Project Title	Dapper's Lane, Angmering	Project No	20079
Client	Persimmon Homes Thames Valley		
Prepared By	S Marshall/C O'Brien	Date	23 rd March 2022
Subject	Civil Engineer Design Development Note (Rev A)

Item	Subject
1.	<u>Introduction</u> This Technical Note has been produced to detail the Civil Engineering design development following receipt and review of the RPS Letter Report dated 07th March 2022 and titled 'Geotechnical and Hydrogeological Review'. This can be used by Arun District Council to understand how the recommendations have informed the revised design and how the recommendations have been suitably achieved, which should close out all design matters and enable a discharge of condition number 18 and 19 in relation to planning ref: A/76/20/PL. The following key should be used for the below stated report recommendations and the respective actions / design decisions / responses: <i>RPS statement from Section 6.2 of their Letter Report: (italics)</i> Response (bold bullet points)

Attenuation Basin Cross Sections

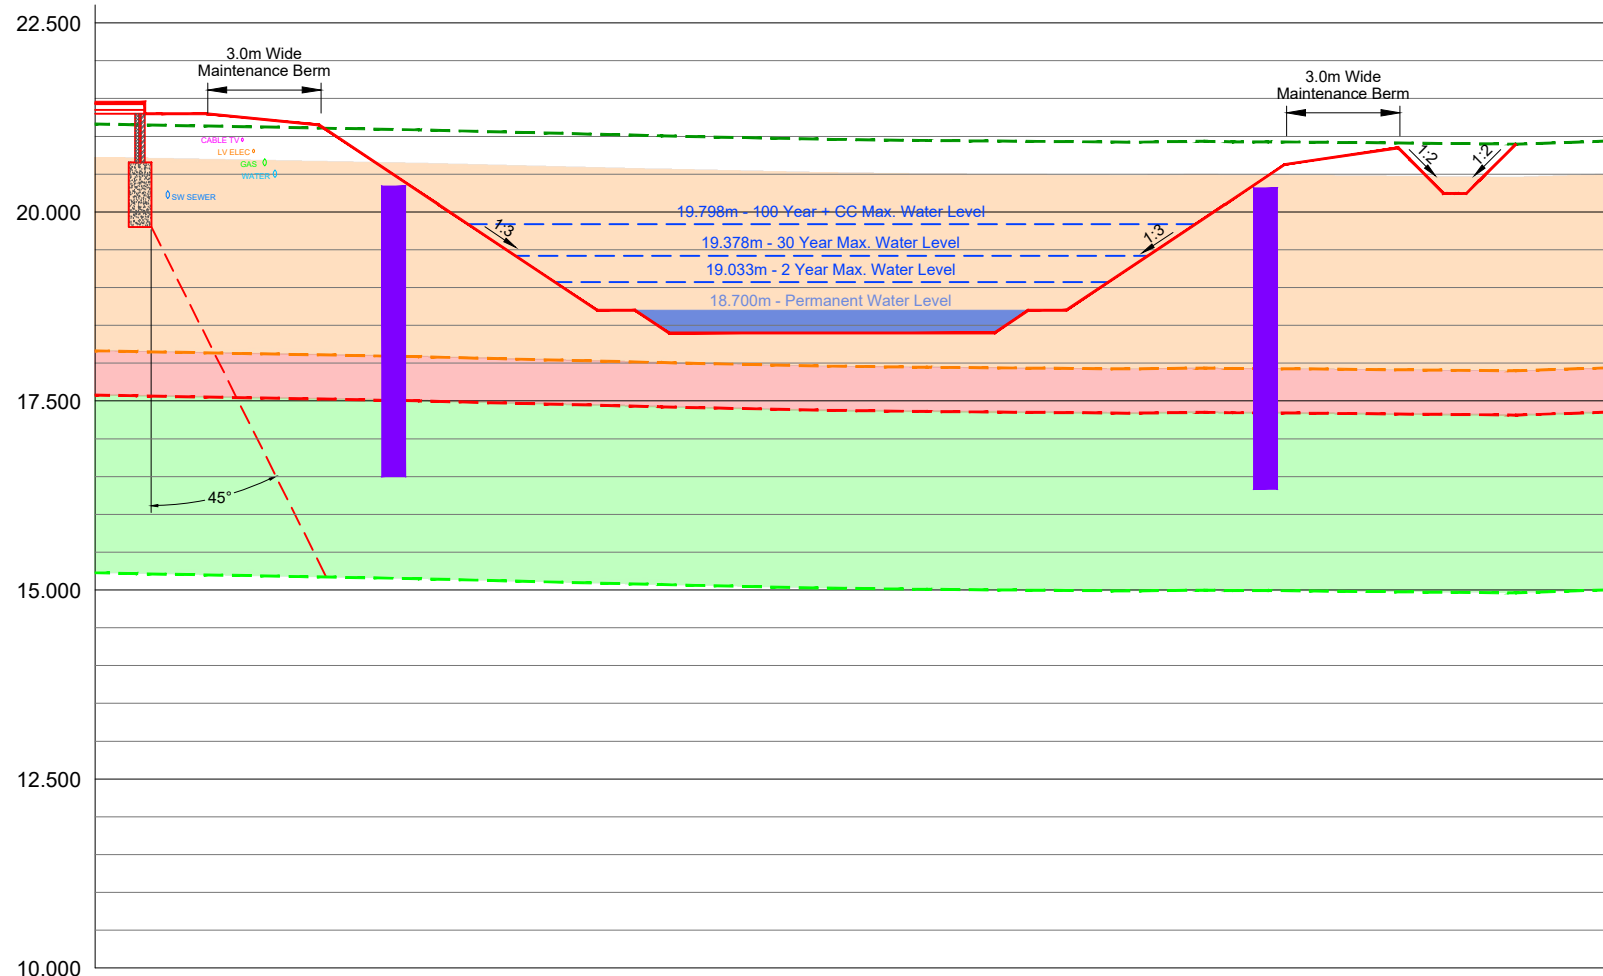
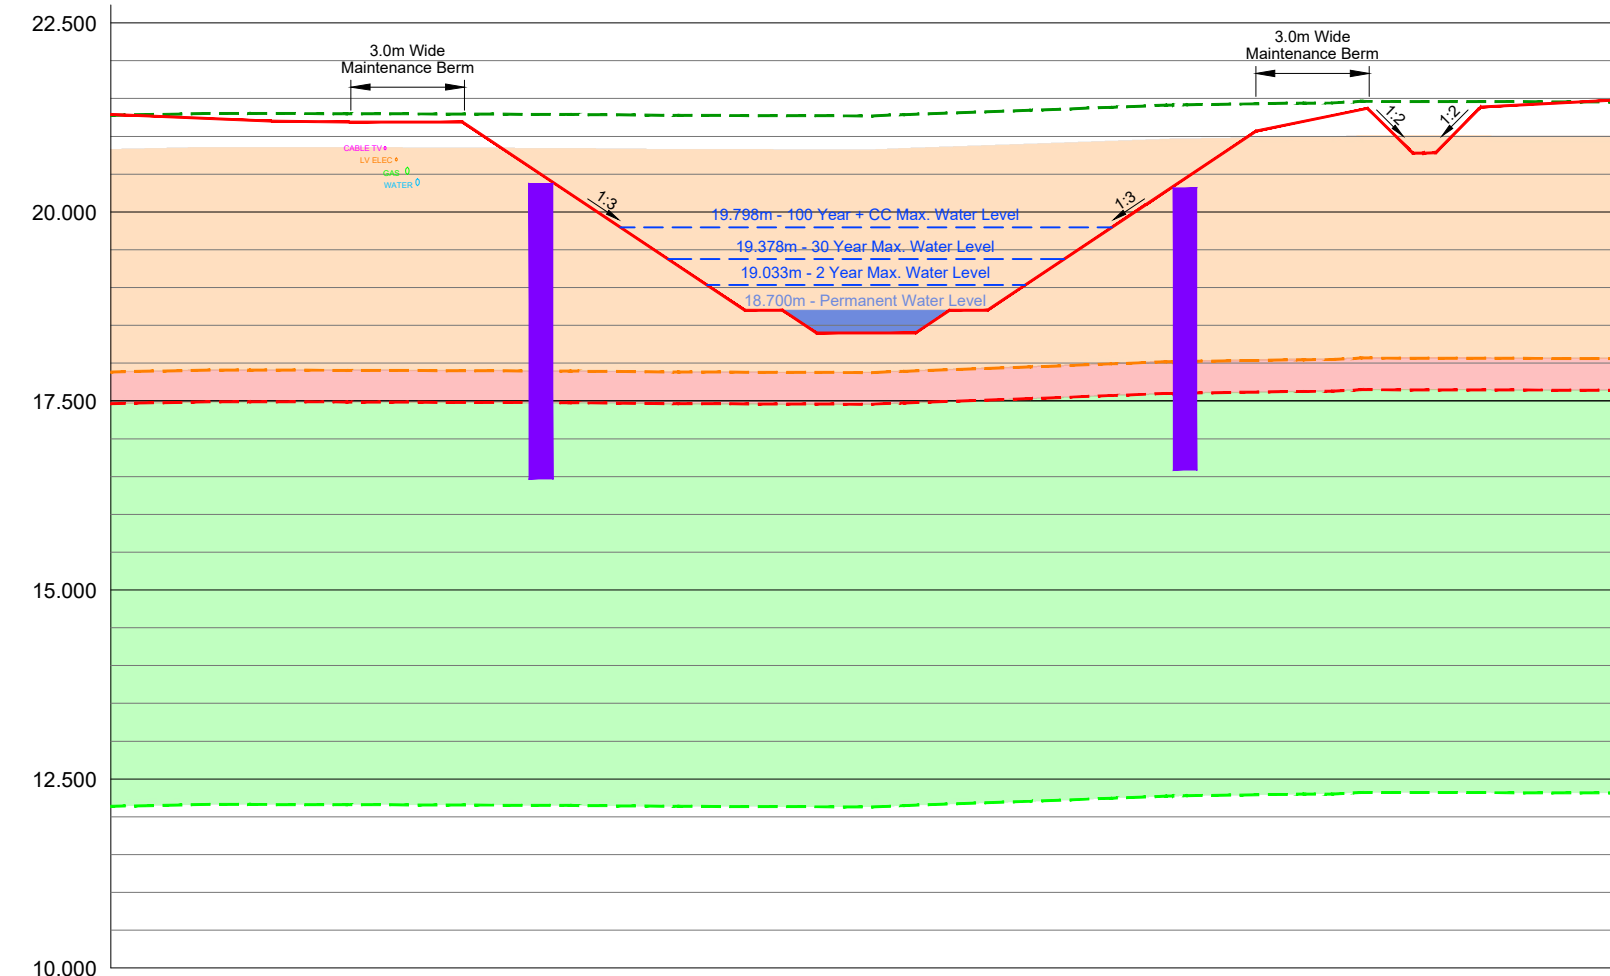
5.	<i>Installation of a cut off wall / drain to the northern and eastern perimeter of pond extending into the top of the London Clay to allow control of groundwater pressures on the side slopes and allow transfer of groundwater to the attenuation pond outfall pipe network and hence prevent groundwater mounding up slope of the pond. The cut off wall/ drain could be used to assist in control of groundwater during construction to facilitate subsequent excavation and placement of clay and geomembrane liners in dry conditions.</i> • A bentonite slurry cut off wall is proposed to the northern and eastern perimeter of the pond to allow control of groundwater pressures on the side slopes. • The cut off wall is proposed to extend 1m into the top of the London Clay to cut off groundwater within the Gravel layer. • The overall depth of the cut off wall is approximately 5m below ground level in order to be keyed into the London Clay. Trenches can be excavated to about 12-15m deep using long reach hydraulic back-actors (backhoes). There are no buildability concerns in relation to this element of the proposed design. • It is unlikely that groundwater will mound and collect on the northern side of the slurry wall due to the granular layer abutting it. This will naturally enable the ground water derived within this gravel layer (as noted in Section 2 of this Technical Note) to flow freely within this layer and around the pond / cut off wall extents via the topography of the site sloping south-west.

6.	<i>Over excavation of the granular layer, from beneath the Attenuation Pond to the top of the London Clay Formation to remove the principal water bearing strata from within the footprint of the pond. The resultant excavation could then be backfilled to pond invert level with a suitable engineered low permeability clay overlain by a geomembrane. The clay liner and geomembrane should extend up the slopes to the proposed crest level.</i> • The granular layer is to be removed from beneath the pond and replaced with low permeability clay overlain by a geosynthetic clay barrier. The geosynthetic clay barrier will follow the geometry of the pond up the banks where it will be tied into the Clay strata no deeper than 600mm bgl. There are no concerns relating to buildability or future maintenance of this method of construction.

- 'HEAD DEPOSITS - CLAY'
- 'HEAD DEPOSITS - GRAVEL'
- 'LONDON CLAY'
- Material to be excavated and replaced with clay
- 'WATERSTRIKE' X/S - 17.00m
- Bentomat CLO.5T Self Geosynthetic Clay Barrier or similar approved
- 600mm Thick Slurry Wall (To be keyed into existing London Clay at least 1m)
